ALBEMARLE COUNTY PLANNING **STAFF REPORT UPDATE**

PROJECT: SP201800016 Ecovillage Charlottesville – Preserved Steep Slopes

PROPOSAL: Disturbance of preserved steep slopes to accommodate the development of private facilities (entrance, accessway, and parking) for the proposed “Ecovillage Charlottesville” residential development.

Existing trees which may or may not be impacted by the proposed disturbance of preserved steep slopes: a mature stand of tall pines (left) and a group of evergreen trees (right). Photographs taken 3/7/2019.

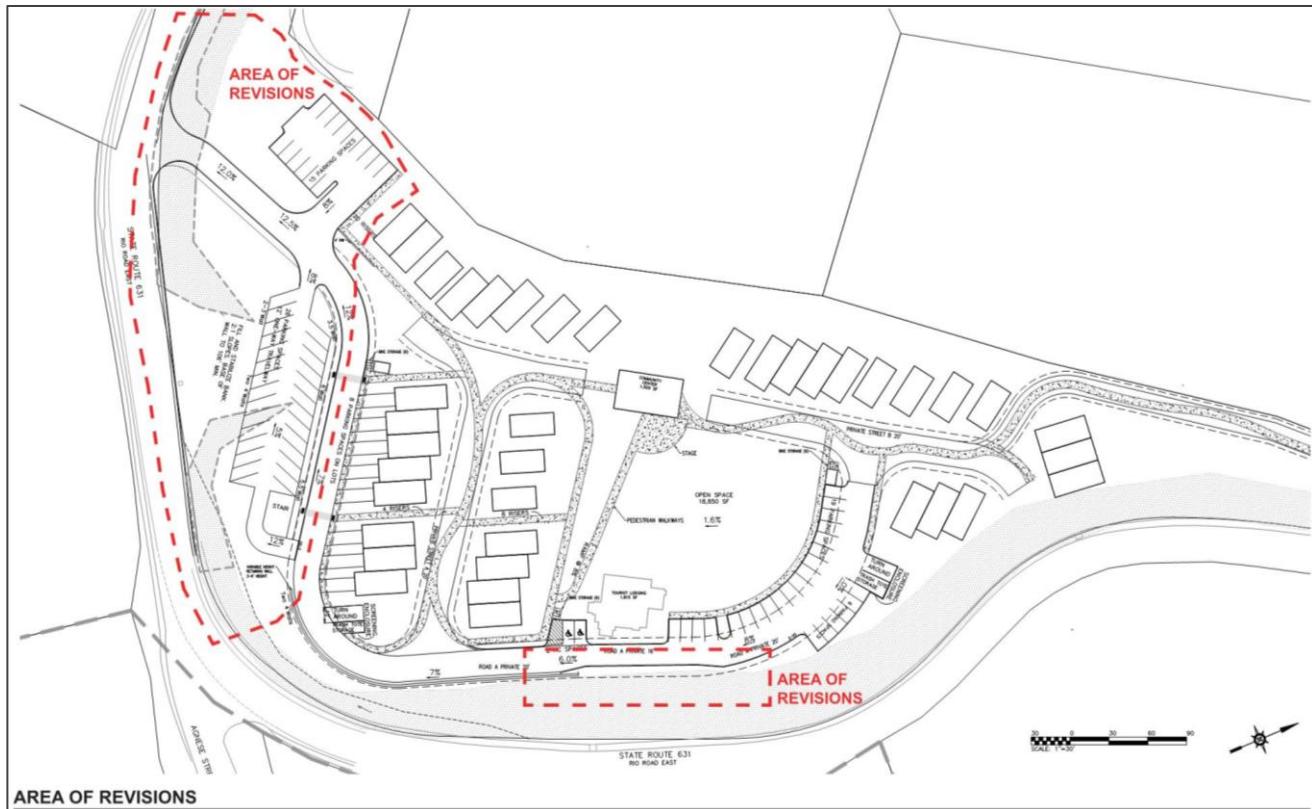
Issue 2 update: To date, the proposed limits of disturbance of preserved steep slopes have not been identified on site by a licensed professional, but the applicants have informally indicated their willingness to arrange for this to be done. Staff believes this would be an important step towards having a more complete understanding of the proposed limits of disturbance, and (in particular) if or how the proposed disturbance would impact certain existing trees. Staff believes particular clarification is important as to whether or not the proposed disturbance would impact a mature stand of tall pines along Rio Road East to the west (downhill) of the proposed entrance, as well as a group of evergreen trees along Rio Road East to the east (uphill) of the proposed entrance. (See photographs below).

Detail of "Habitat Planting Plan" and "Landscape Schedule" (Att. H) with a revision date 2/26/2019; compare to page 26 of "Supplementary Exhibits" packet (Att. G) dated 2/4/2019.

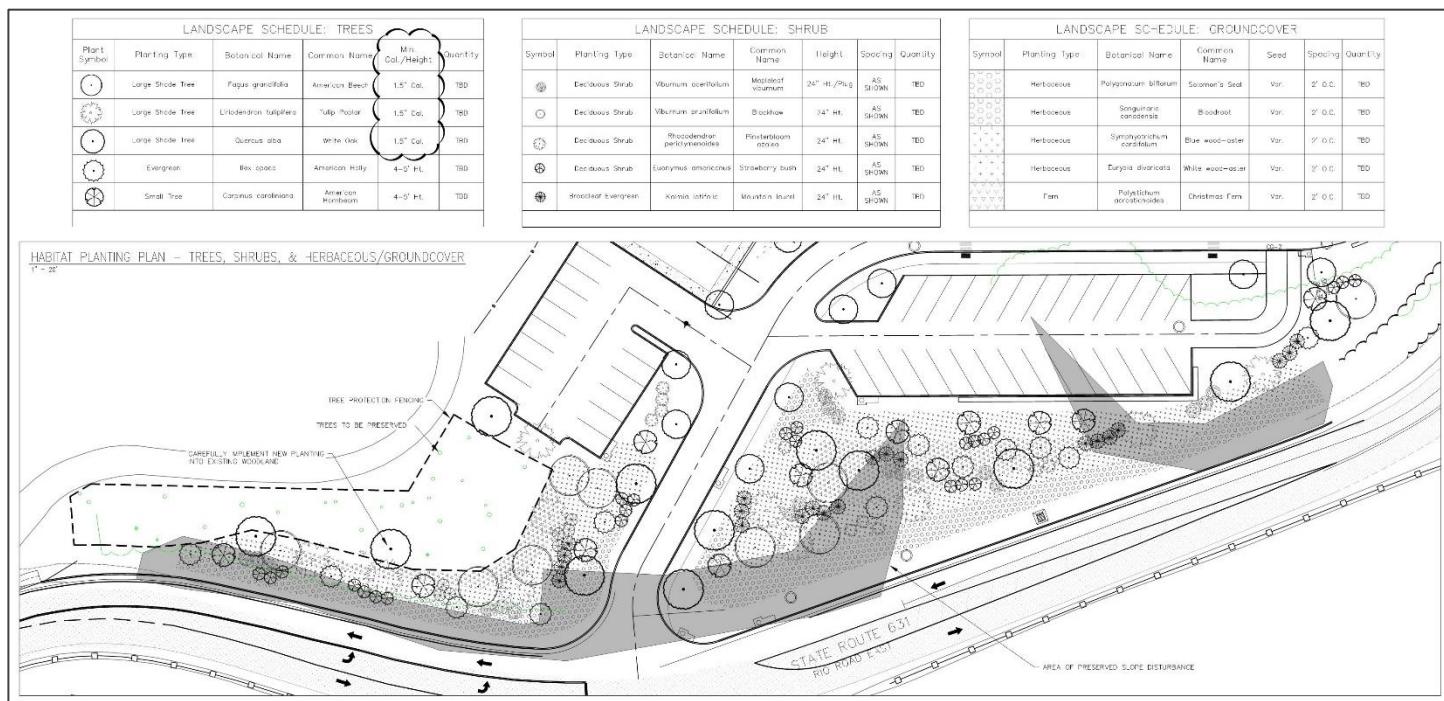
However, the mitigation techniques shown on the planting plan are conceptual in nature. This conceptual level of detail makes it difficult to determine if the quantity and locations of proposed landscaping are

sufficient. More specifically, the conceptual level of detail and unspecified quantifications prevent staff from being able to make the following positive findings about the Habitat Planting Plan: that it would sufficiently mitigate impacts to the character of the steep slopes overlay district and nearby area; and that it would sufficiently mitigate the impacts to the ecological and hydrological performance of the existing landscape that would result from the proposed grading and removal of existing vegetation; and that it would provide sufficient screening for the proposed parking area private facility as viewed from Rio Road East. These are all relevant factors to consider when evaluating this proposed special use permit. Please also note that some screening of the parking area is otherwise required pursuant to Zoning Ordinance Section 32 (Site Development Plan), Subsections 32.7.9.5.e (“Landscaping Along Streets – Shrubs along public streets.”) and 32.7.9.7.a.2 (“Screening – Parking areas.”).

Despite the limitations stemming from the conceptual level of detail and quantifications, the new Habitat Planting Plan embodies desirable design concepts and is a strong starting point for addressing replacement landscaping and habitat. However, staff opinion is that additional landscaping is needed in the form of additional evergreen shrubs and evergreen trees at strategic locations in the vicinity of the proposed parking area private facility, in order to ensure sufficient screening of this proposed private facility within the preserved steep slopes overlay district in a way that appropriately mitigates the impacts to the character of the district and nearby area.

Staff also believes that the proposed habitat planting plan should be further revised to include a certain number of plant materials to be specified at a larger height or larger caliper (as applicable) than the minimum required height or minimum required caliper. Staff acknowledges that smaller plant materials may eventually take root and thrive more successfully over time than plant materials which are larger, taller, or have larger root balls at the time of planting. However, plant materials that are larger at the time of planting would significantly help to provide more immediate mitigation of the impacts to the character of the steep slopes overlay district and nearby area. Therefore, staff believes that a certain portion (25% - 33%) of the shrub, understory, and canopy plant materials in the vicinity of the proposed parking area private facility should be specified to be larger than the minimum required height or caliper.

- a. The "Landscape Schedule" for the "Habitat Planting Plan" must be revised so that a certain portion (25% - 33%) of the tree plant materials and shrub plant materials are specified at a minimum caliper or minimum height that, at the time of planting, meets the minimum size requirements for landscaping materials as would be required within the Entrance Corridor.

- b. The "Habitat Planting Plan" must be revised to be supplemented with additional numbers of evergreen shrubs and evergreen trees at strategic locations in the vicinity of the proposed

parking area private facility in order to sufficiently provide screening for this proposed private facility within the preserved steep slopes overlay district. A certain portion (33% - 66%) of these vegetative screening materials in this vicinity shall be specified at a minimum caliper or minimum height that, at the time of planting, meets the minimum size requirements for landscaping materials as would be required within the Entrance Corridor.

Detail of "Proposed Entrance Layout" exhibit (Att. I – revision date 2/27/2019); compare to "Stormwater Improvements" exhibit on page 22 of "Supplementary Exhibits" packet (Att. G) dated 2/4/2019.

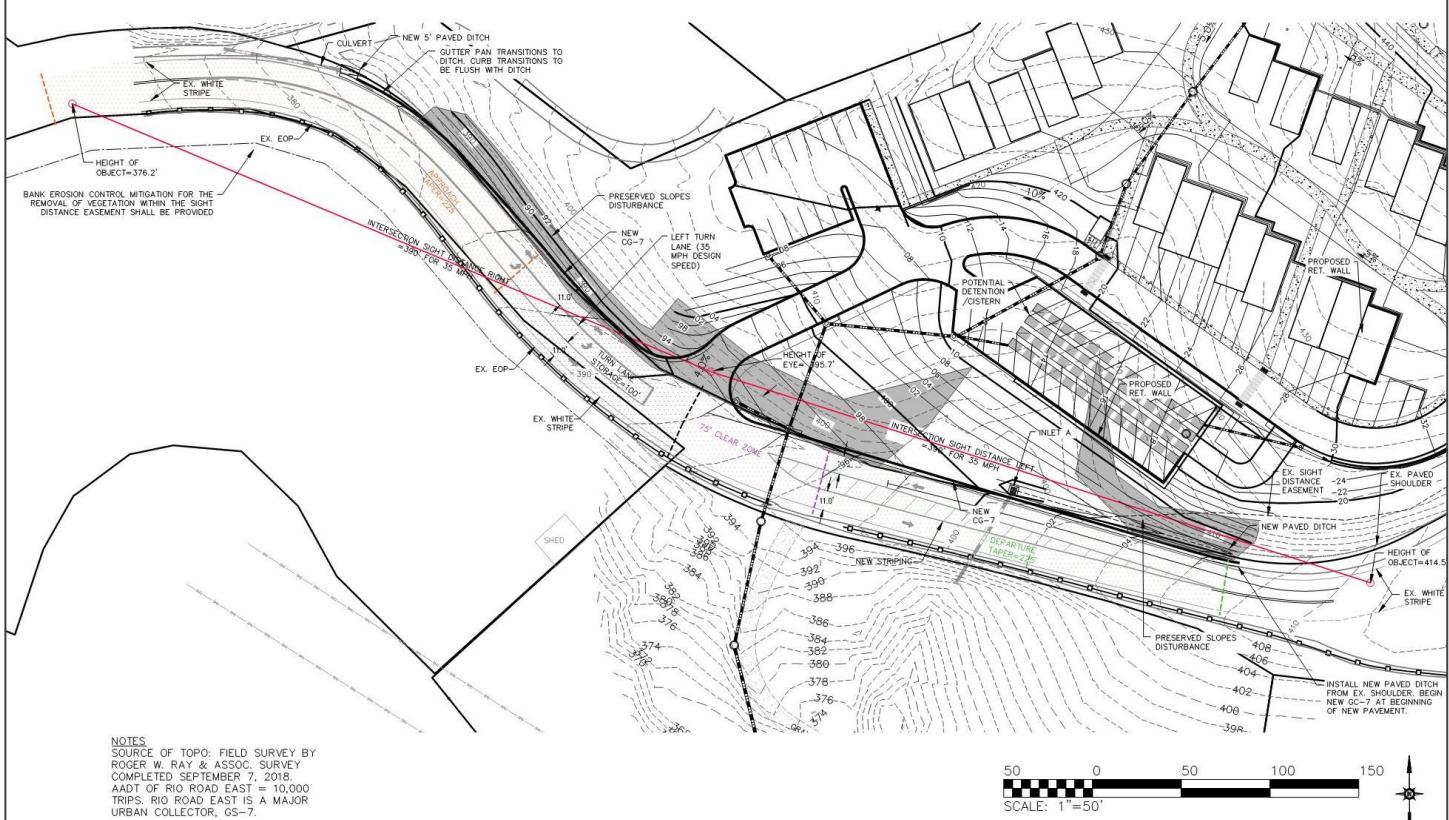
Mr. Pohl indicated that the conceptual plans, exhibits, and other information contained in the resubmittal application materials represent an appropriate combination of mitigation techniques, provided that certain important details are properly addressed (finalized) during future review processes for a Final Site Plan and Water Protection Ordinance Plan. Mr. Pohl's concerns and recommendations relate to the following:

- The importance of providing treatment of stormwater (for water quality) on-site;
- The importance of proposed grading not including any slopes in excess of 33% grade;
- The importance of using a 25-year design storm (instead of the conventional 10-year design storm); and
- Detailed comments relating to the location and design of stormwater and drainage improvements.

- a. All modified or newly constructed slopes will have a grade that does not exceed a 3:1 slope.
 - b. Drainage improvements along Rio Road East will be designed to manage the 25-year storm event without flooding.

- c. Curb inlets will be provided on both sides of the new entrance to collect site runoff before it enters the Rio Road East right-of-way.
 - d. The specific materials and practices for the proposed "off-site bank erosion control" will be approved by the County Engineer.
